Year 3 Monitoring Report

LITTLE SEBASTIAN SITE

NCDMS Project # 100027 (Contract # 7187) | RFP 16-006993 (Issued 9/16/2016)
USACE Action ID: SAW-2017-01507 | DWR Project # 2017-1041

RE: Little Sebastian, Project ID #100027, DMS Contract #7187

MY3 Little Sebastian JN2-B Flow Gauge Graph

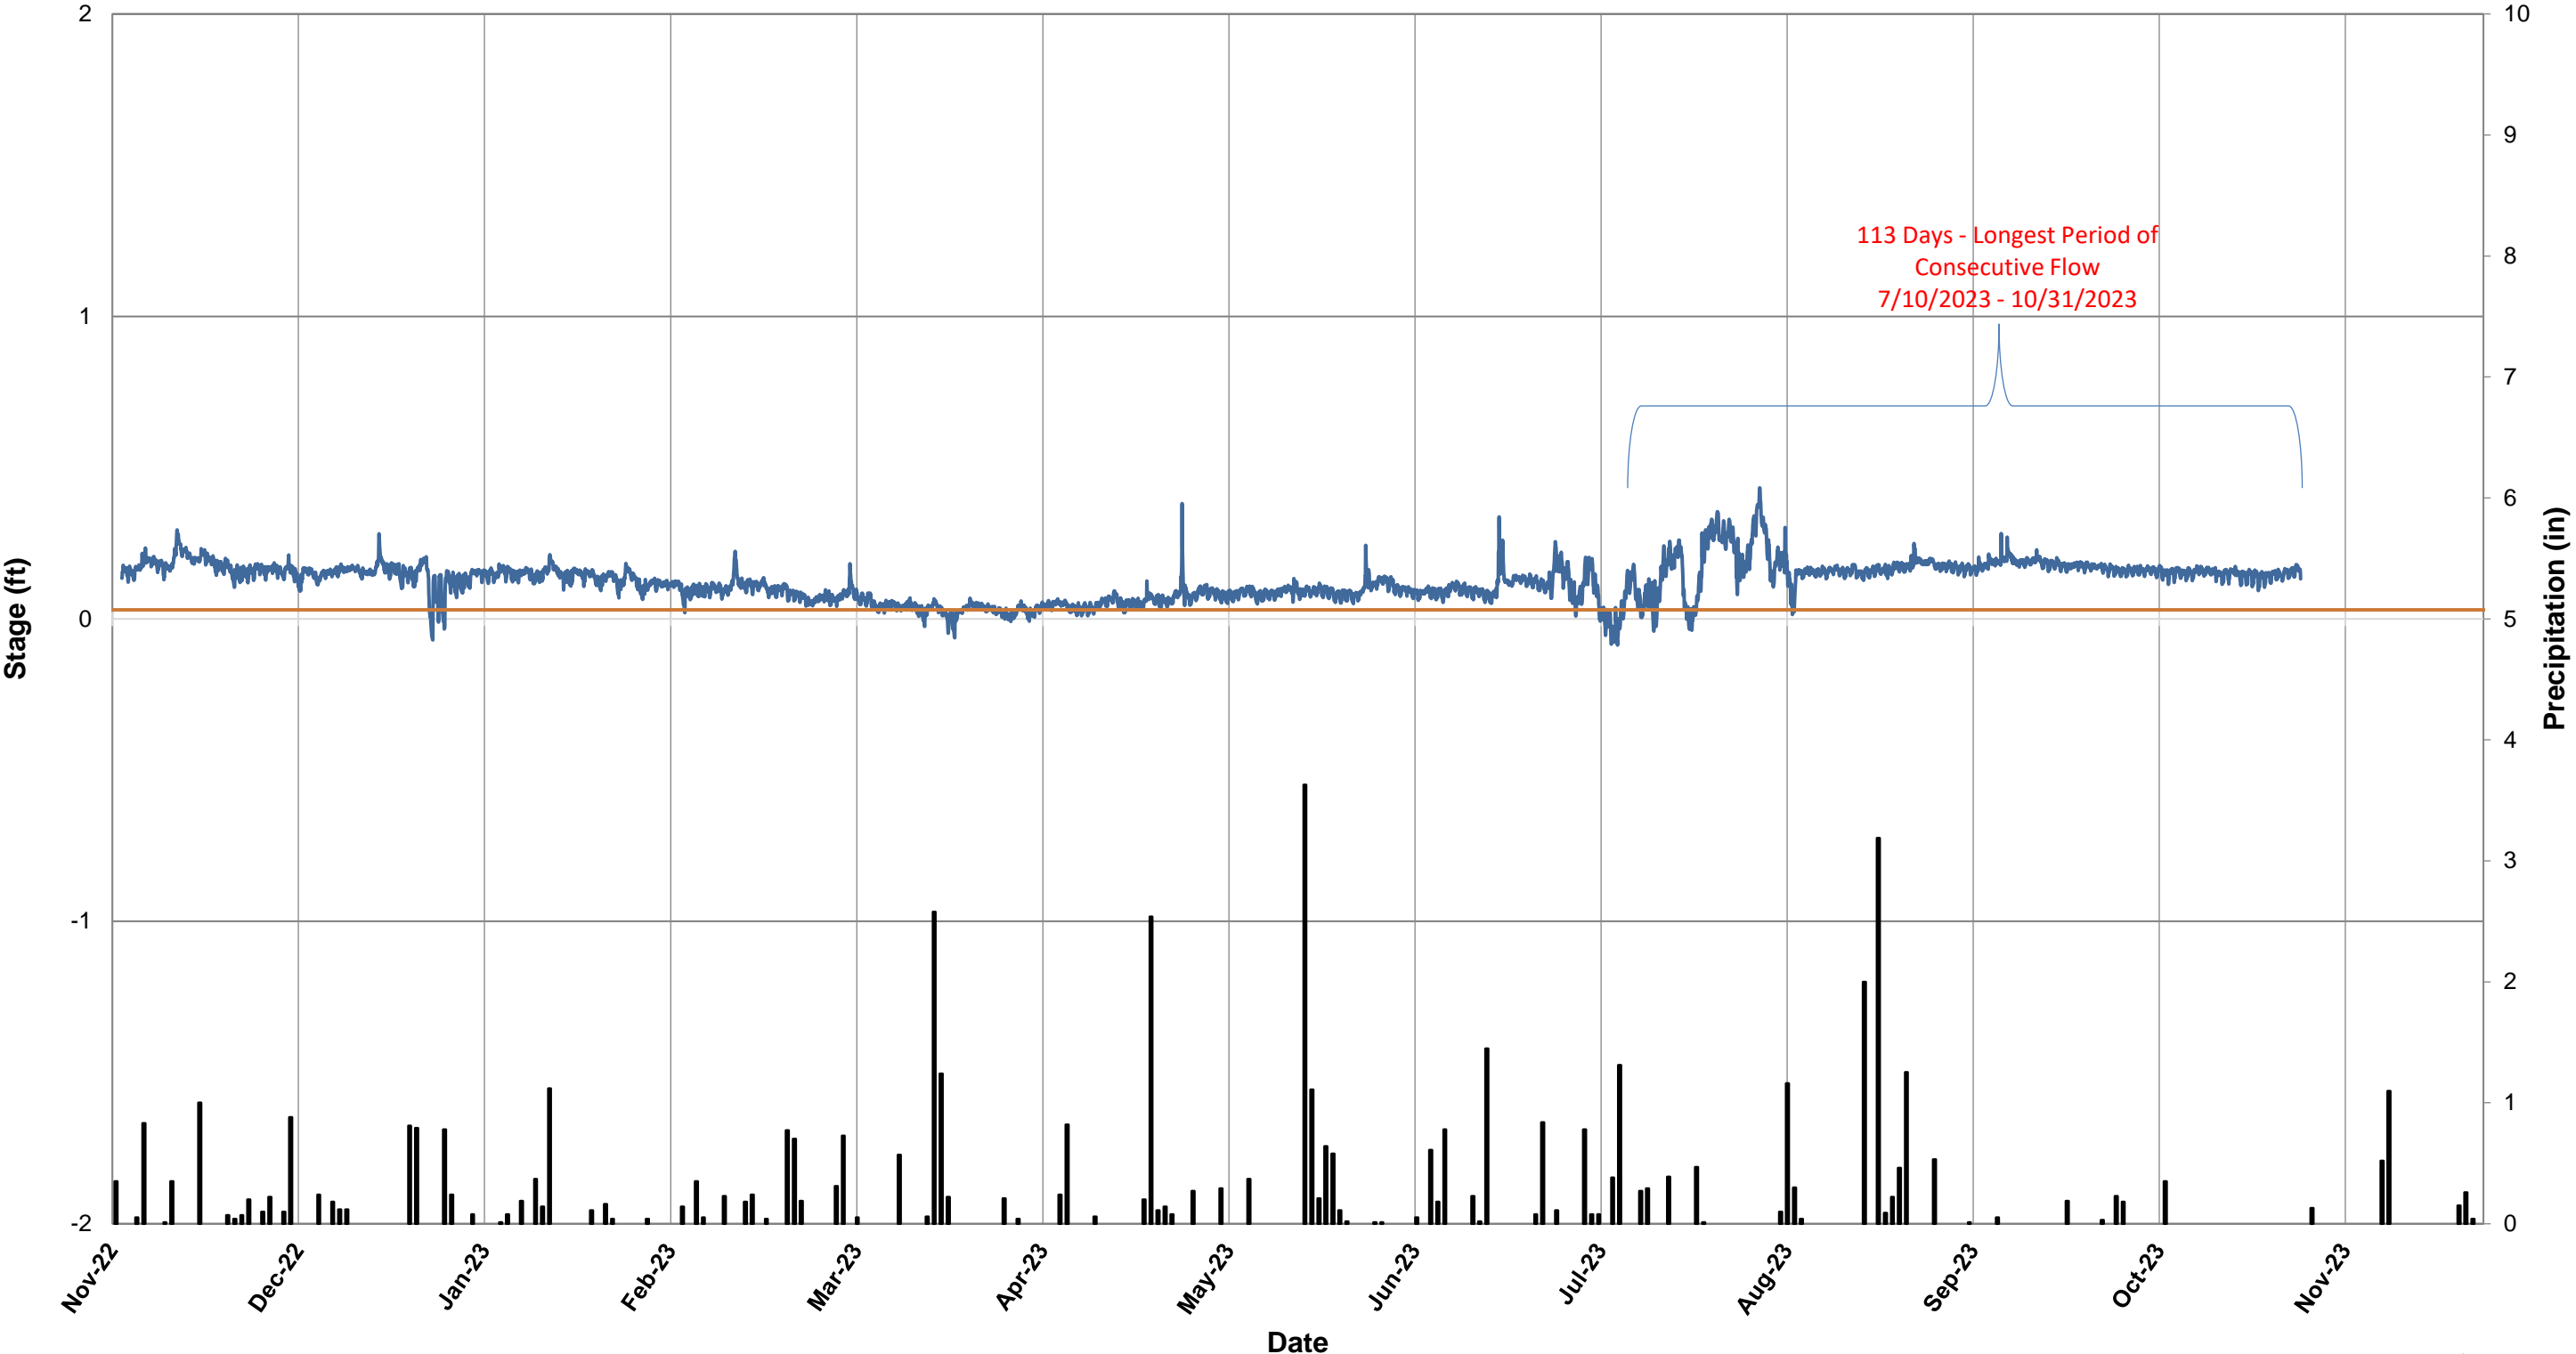
17. MY3 Little Sebastian Flow Gauge Graphs (all): The Longest Period of Consecutive Flow callouts shown have numerous instances where the water line drops below the Downstream

Riffle Elevation Line. Please review and revise the report as necessary. Please explain why consecutive flow data reported includes instances when the waterline drops below the downstream riffle elevation.

All of the flow gauges drop below the downstream riffle elevation during the longest period of consecutive flow; however, the gauge reads 24 times a day and for the instances that where the water level drops below the downstream rifle it is less than 24 hours in a row. The consecutive day count does not stop until there is 24 hours in a row where there is flow less than the downstream rifle. Please reference the flow gauge raw data in the digital files (5. Hydrology Data) to see where the determinations come from.
